S E R V I C E N O T E

HP 70846A 3Gbit/s Error Detector Module**Serial Numbers:** 3017U00101 / 3206U00114**Module causing Mainframe/Display Shutdown****Situation:**

DATE: 11 August 1992

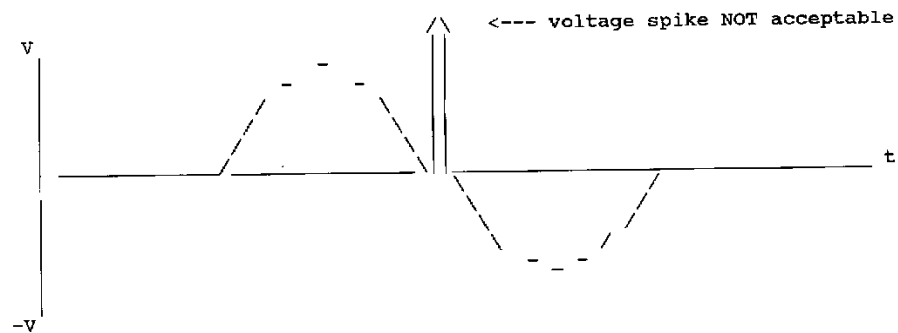
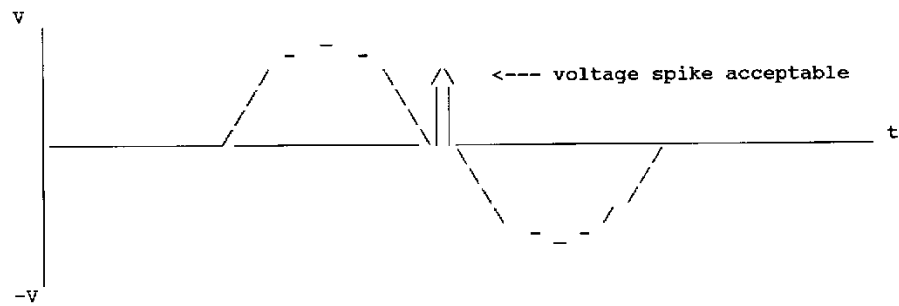
If the fault is found to be shutdown of the Mainframe/Display caused by the HP 70846A Error Detector Module and the module serial number is within the range specified above, then suspect excessive voltage spike feedback from the A2 Power Supply Assembly.

4. Fit the module extender assembly HP p/n 70001-60013 into the Mainframe (or Display) and attach the cable from this extender assembly to the socket on the rear panel of the HP 70846A module.
5. Connect an oscilloscope to TP 40kHz on the module power supply assembly HP p/n 70841-60002.
6. Switch on the Mainframe (or Display) and adjust the oscilloscope timebase and amplitude to display a single pulse across the screen. Some ringing on this pulse is acceptable, but if the voltage spike appears excessive the PSU should be changed for new assembly HP p/n 70841-60102.

7. With the new PSU assembly fitted, check the typical supply voltages are as shown here (test points exist for these).

+5V, +8V, +10V, +15V, +17V, +35V, -2V, -5.2V, -15V, -20V
8. Reassemble the module (reversal of dismantling procedure - DO NOT FORGET the plastic board spacers).
9. Fit the module in Mainframe/Display and carry out the semi-automatic calibration procedure using the FTM calibration programs supplied by QTD.
10. Perform module Operational Verification as described in Section 4 of the 71600 Series Installation and Verification Manual.
